Access Compliance Report Public Rights-of-Way (Curb Ramps)

Intersection ID: 5296 Main Street: GROVE LAKE DR Cross Street: N_TRYON_ST Location: ADA ID: 4E2B1274F705 Ramp Type: Perp Initial Pass/Fail: Fail **Overall Compliance: No** Severity Score: 21.25

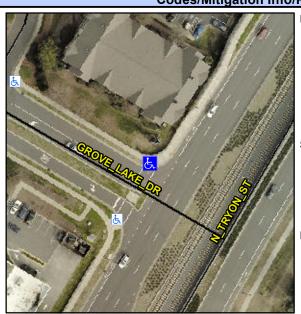
Field Measurements/Component Compliance					
Compliance Description		Data	Comp	oliance Description	Data
N/A	Ramp Length (in)	48.0	No	Ramp Slope (%)	8.5
No	Ramp Width (in)	47.0	Yes	Ramp XSlope (%)	0.8
N/A	Flare Type LT	N/A	N/A	Flare Type RT	N/A
N/A	Flare Slope LT (%)	N/A	N/A	Flare Slope RT (%)	N/A
N/A	Flare Traversable LT?	N/A	N/A	Flare Traversable RT?	N/A
N/A	Landing Length (in)	N/A	N/A	DWS Provided?	N/A
N/A	Landing Width (in)	N/A	N/A	DWS Contrast?	N/A
N/A	Landing Slope (%)	N/A	N/A	DWS Length (in)	N/A
N/A	Landing X Slope (%)	N/A	N/A	DWS Full Width?	N/A
N/A	Landing Curb? (Y/N)	N/A	N/A	DWS Offset (in)	N/A
N/A	Shared Landing?	N/A			
N/A	Gutter Ponding?	N/A	N/A	Gutter Slope (%)	N/A
N/A	Gutter Lip Ht (in)	2.0	N/A	Gutter X Slope (%)	N/A
N/A	Painted X Walk1?	Yes	N/A	Painted X Walk2?	N/A
	X Walk 1 Direction	To SW		X Walk 2 Direction	N/A
N/A	X Walk 1 Width (in)	90.0	N/A	X Walk 2 Width (in)	N/A
	X Walk 1 Slope (%)	4.9		X Walk 2 Slope (%)	N/A

GROVE LAKE DR Street 1 Name StopSign Stop Condition-Street 2 Street 2 Name N/A Stop Condition-Street 1 N/A Possible Solutions: Remove & Replace Entire Ramp. Surveyor Notes: N/A PROW/ADA: R304.5.1, R304.2.2
